**SITE PLAN WITH AERIAL**  
**WEBER CARPET**  
 LEE'S SUMMIT, JACKSON COUNTY, MISSOURI

Re: Responses to City Comments  
Commercial Preliminary Development Plan, PL2017064  
PEI # 170069

**Analysis of Commercial Preliminary Development Plan:**

**EXTERIOR ELEVATIONS**

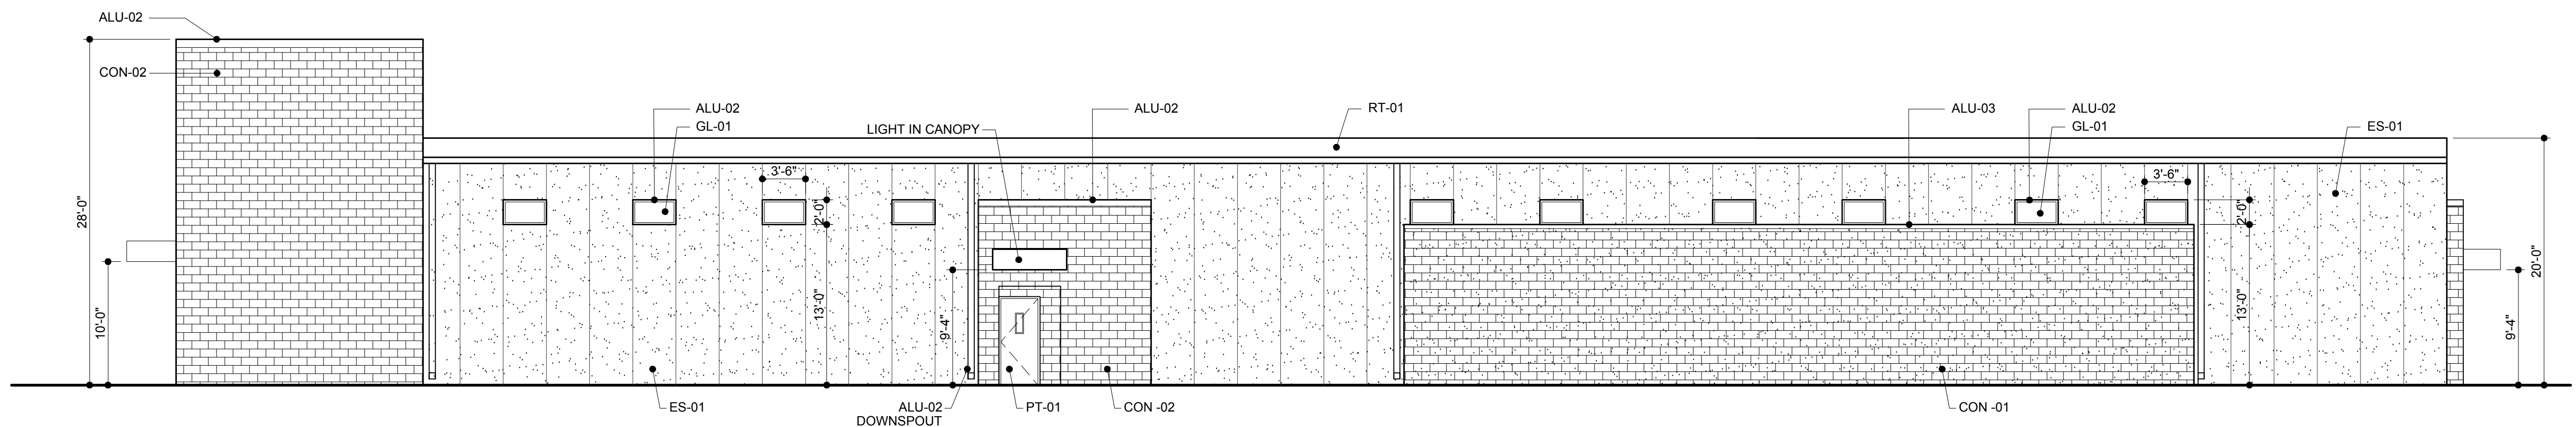
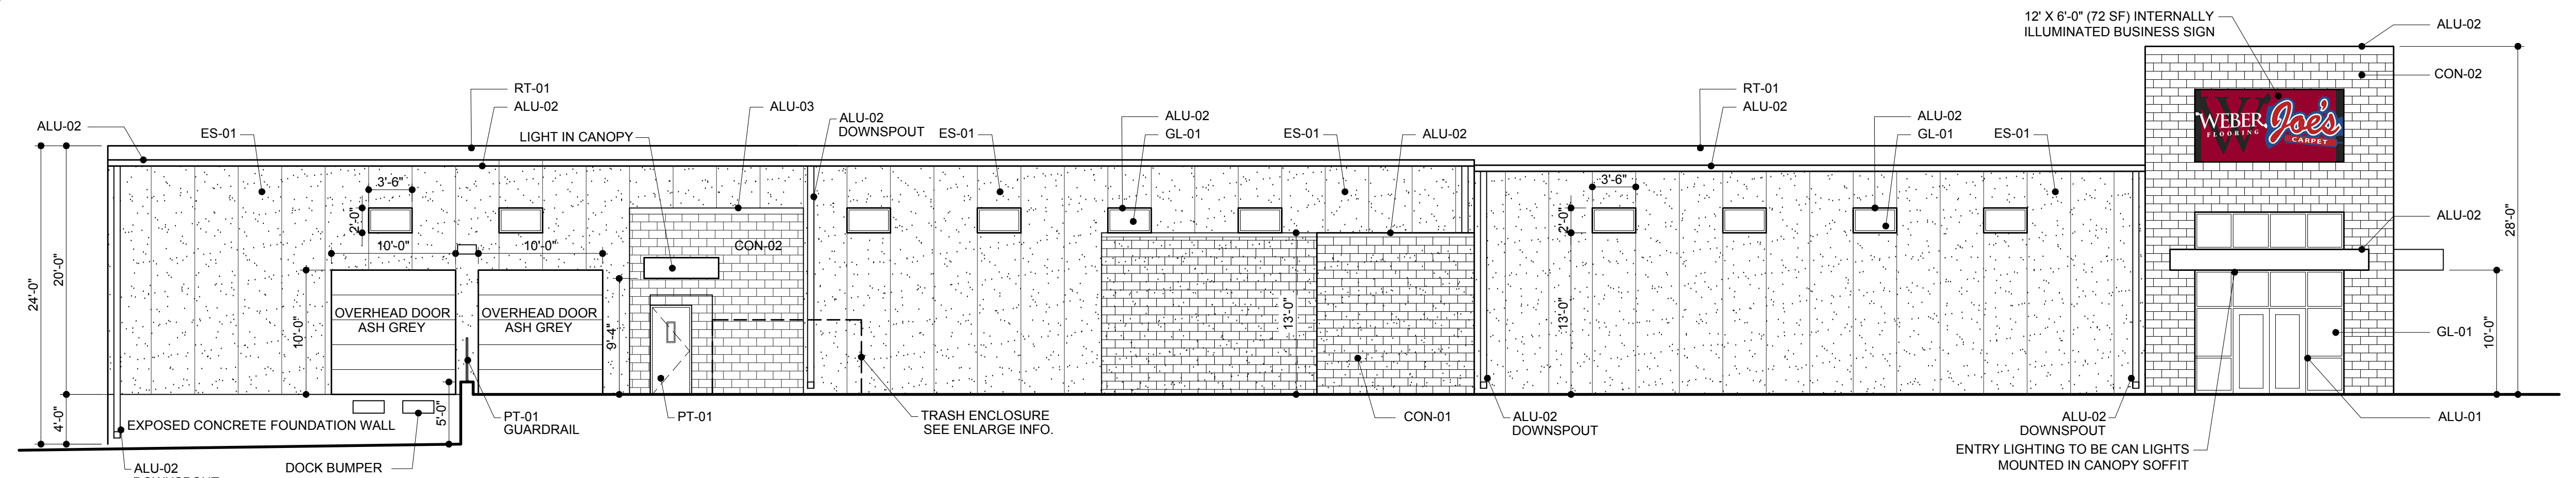
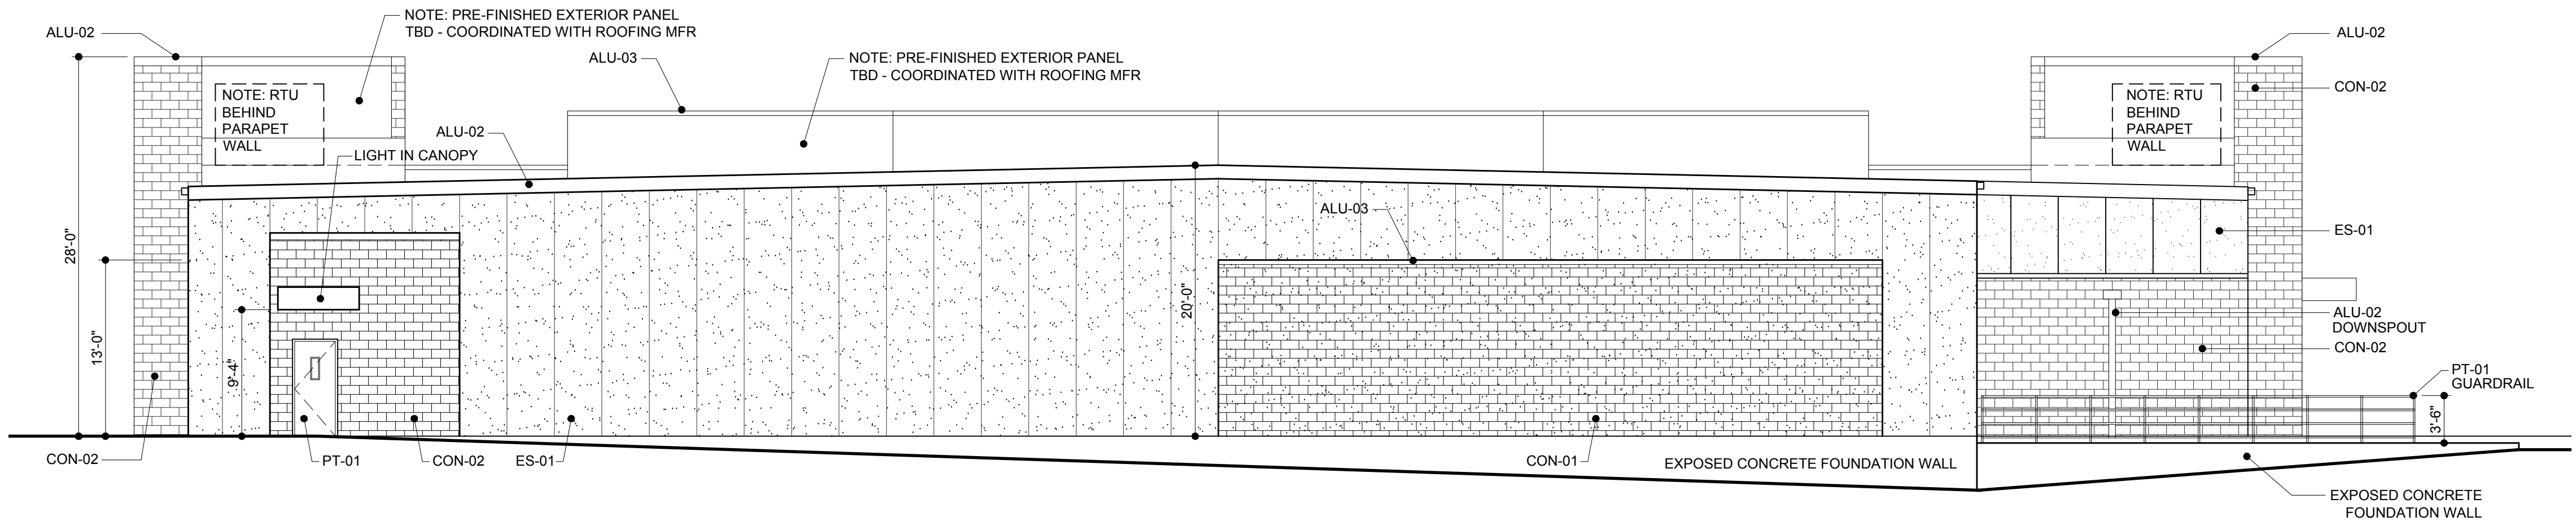
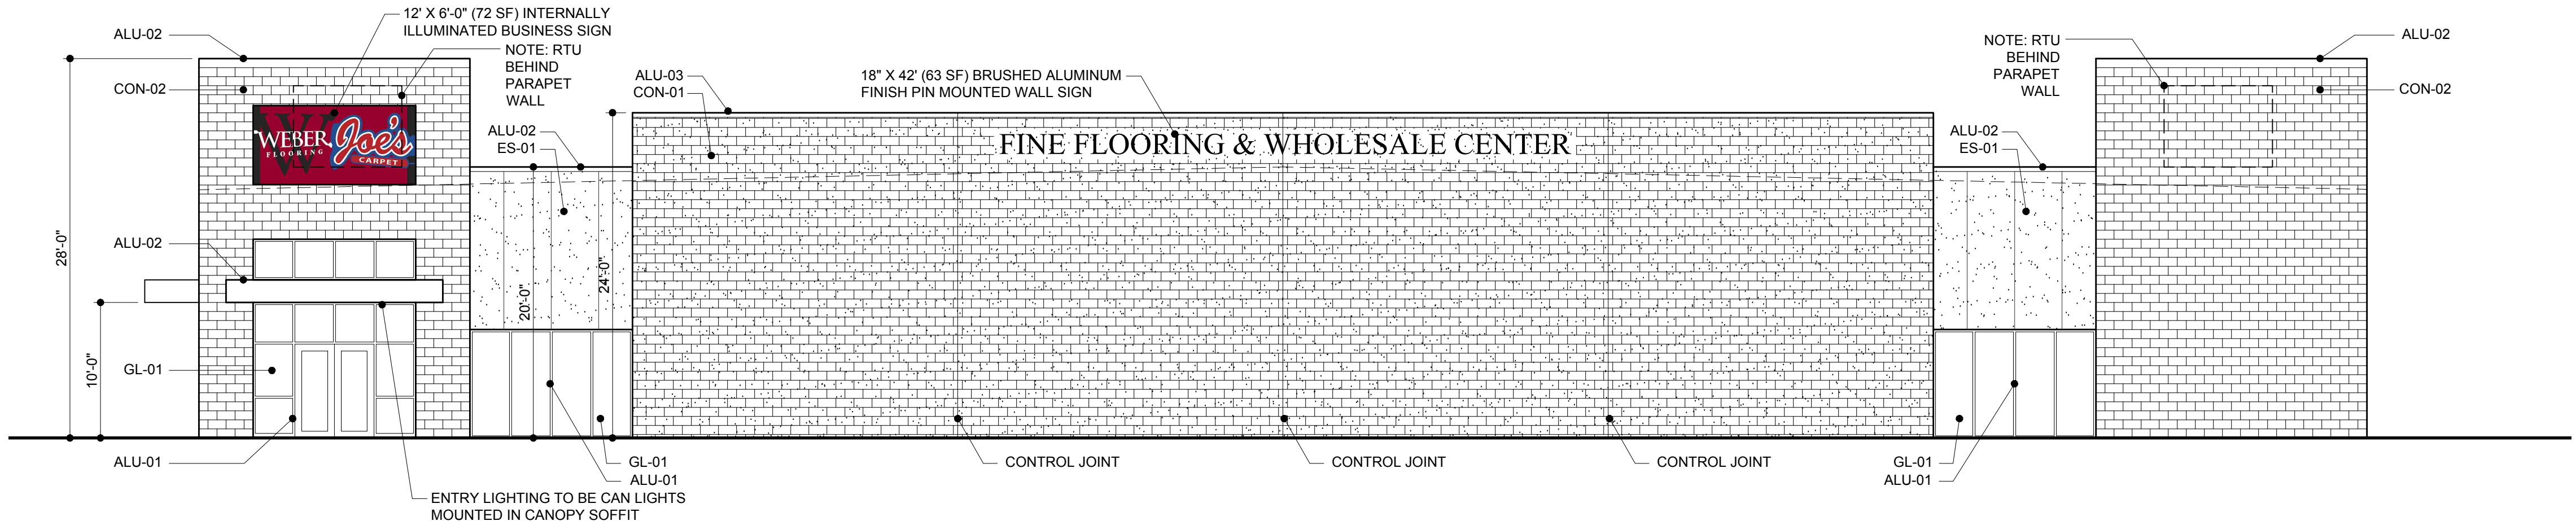
14. The elevations are lacking the required architectural elements. All sides of the building shall have four sided architecture and include similar architectural details, materials and colors to avoid a back side presentation to other buildings or residential neighborhoods. Horizontal and vertical elements shall extend completely around the building and utilize the same or similar materials on all building facades. Offsets, vertical/horizontal breaks shall be provided on all sides of buildings to provide architectural relief.

21. Dash in RTU locations on all elevations to verify that parapet screening requirements are met.

*Response: See revised elevations and renderings. Each of the exit/egress doors has been offset by 16" from the primary building perimeter and highlighted with a masonry accent and canopy that is consistent with the architecture of the entry accent tower element. The accent masonry color has also been carried to all four elevations in areas that are not part of an entry – again in keeping with the architectural language of the primary front elevation. The architecture has chosen to highlight the vertical nature of the stucco composite panels while adding the horizontal datum features in the masonry areas only. The canopies are consistent in size and detail, and the windows have all been sized/aligned to create a consistent pattern that will allow natural light into the interior showroom and warehouse spaces.*

*Response: See revised elevations. The RTU's are located behind the two primary elevation entry towers.*

**6 TRASH ENCLOSURE**  
1/4" = 1'-0"

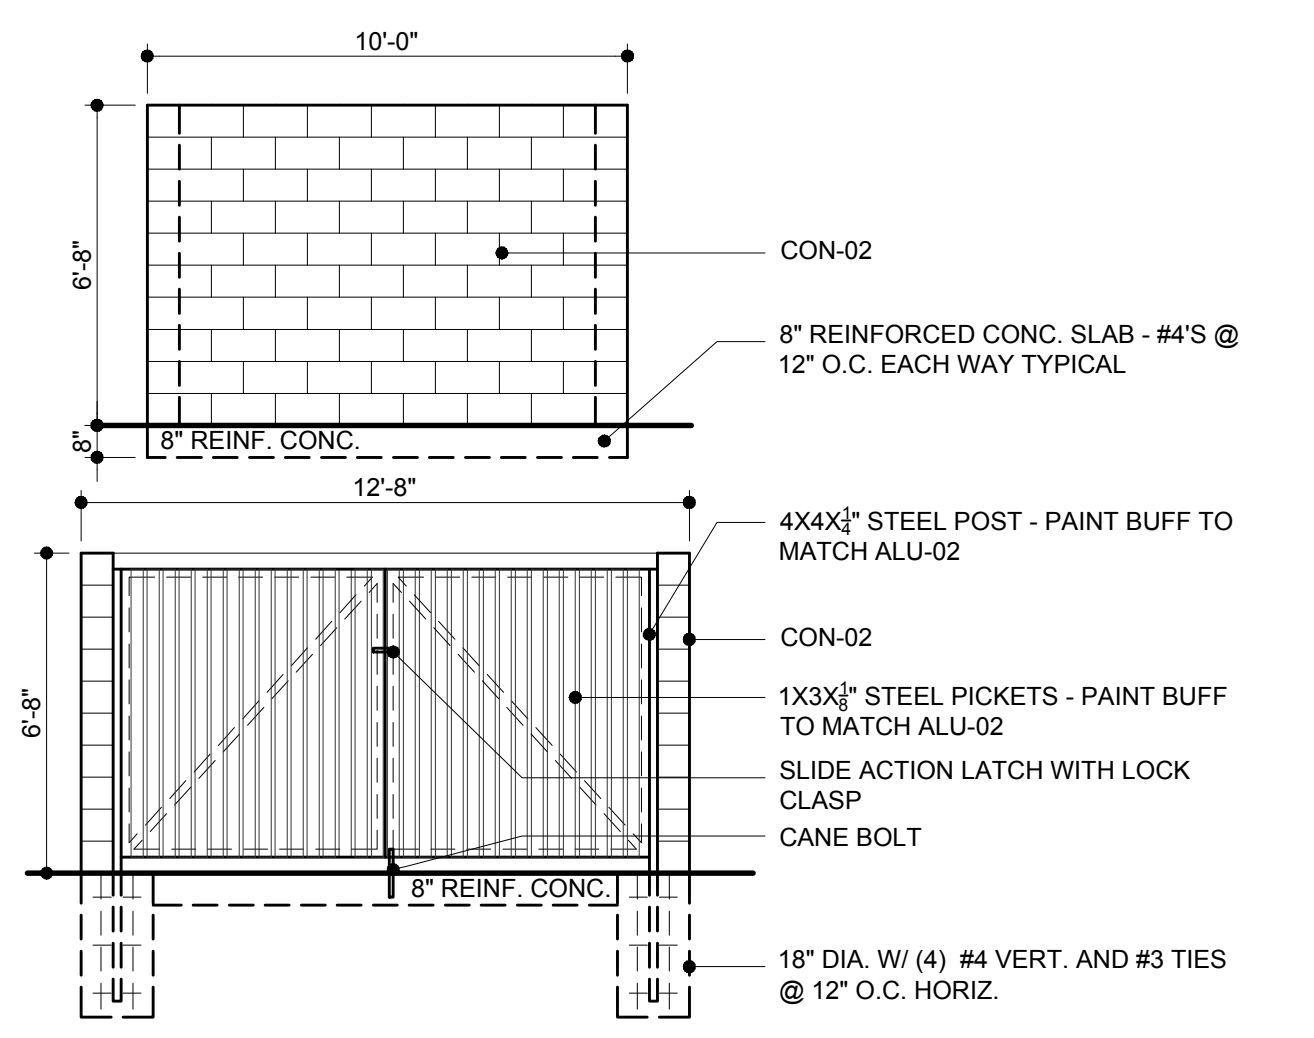
12. Please provide trash dumpster screening details. The dumpster enclosure shall be constructed of masonry walls and solid steel gates painted to be compatible with the enclosure walls.

*Response: See revised project elevation sheet indicating the size and construction as requested. trash enclosure is 100% masonry with solid steel gates painted to match trim as indicated.*

**PH-1.0**

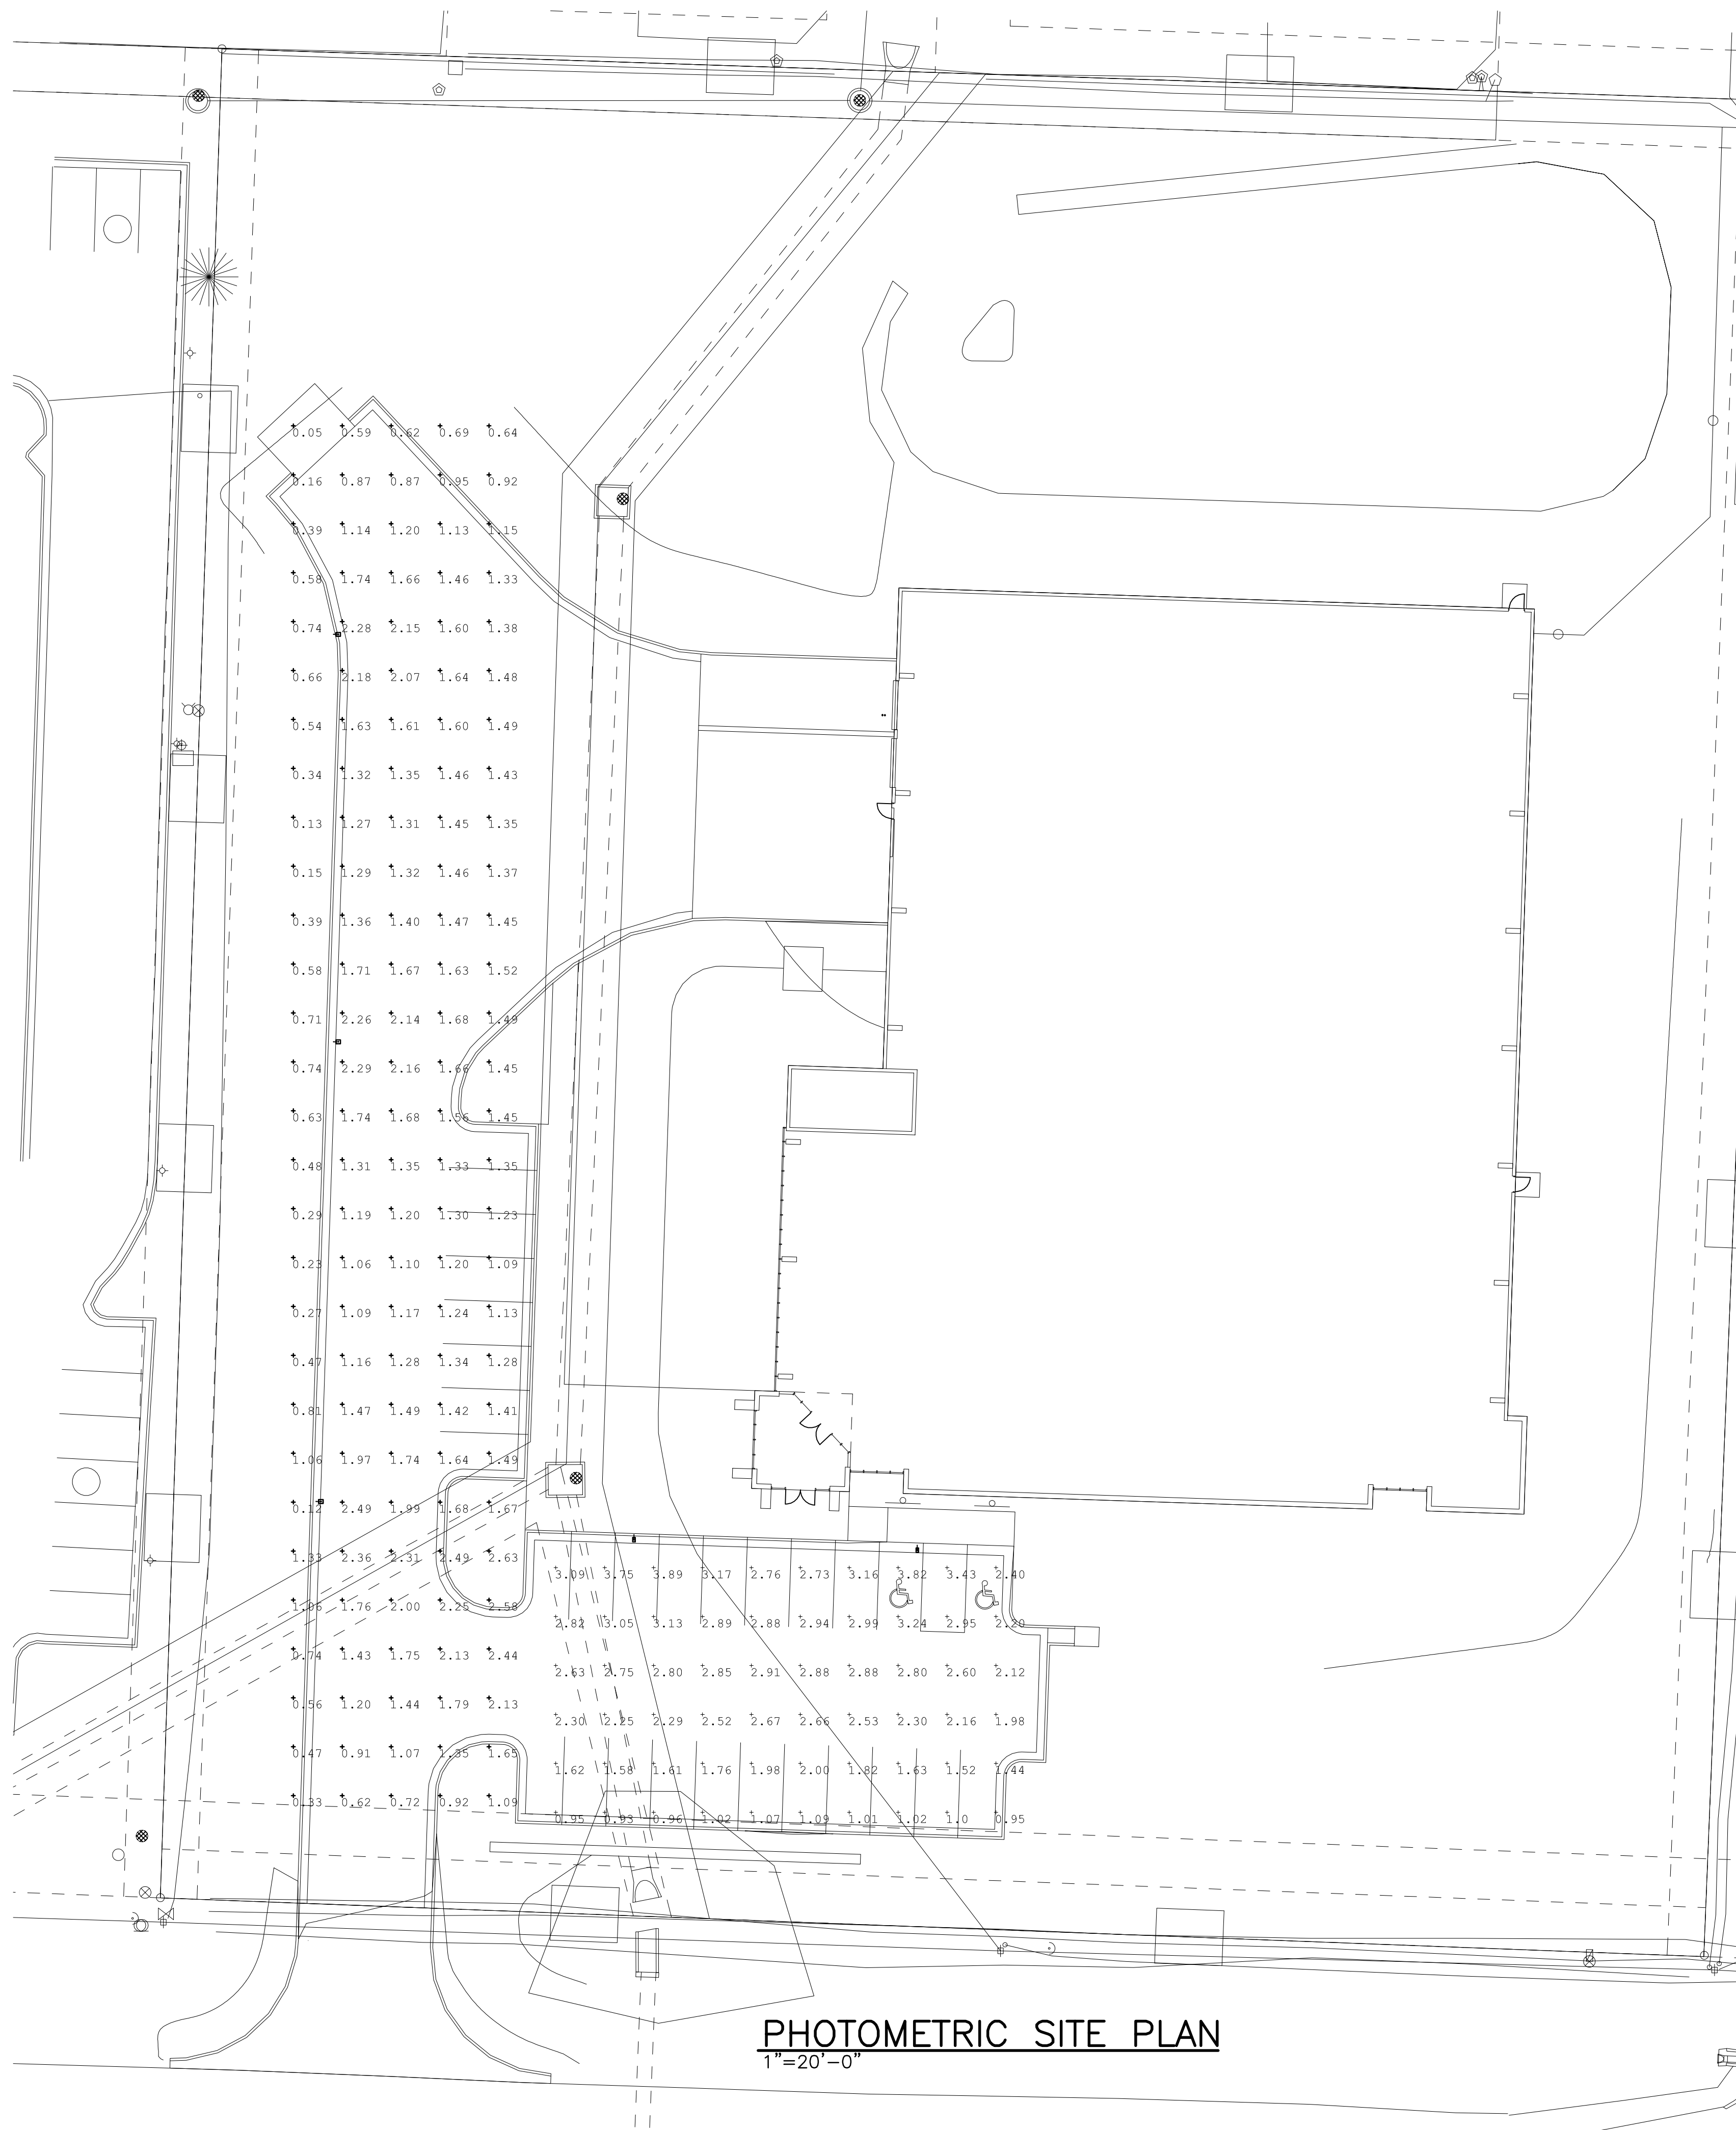
4. Please provide details showing that all lighting used to illuminate the site is arranged, located or screened so that light is directed away from and no light source is visible from a public street, a residentially zoned area or a residential use. Provide manufacturer specifications of all exterior light fixtures to review for compliance with Article 7, Division V of the UDO.

5. Please provide a photometric plan showing the lighting levels throughout the site and at the property lines.

*Response: See attached Sheet PH-1.0. Lighting locations and photometric levels are indicated. Manufacturer's Spec sheets have been included for reference and specific fixture is labeled on sheet.*

*Response: See attached Sheet PH-1.0. Lighting locations and photometric levels are indicated.*
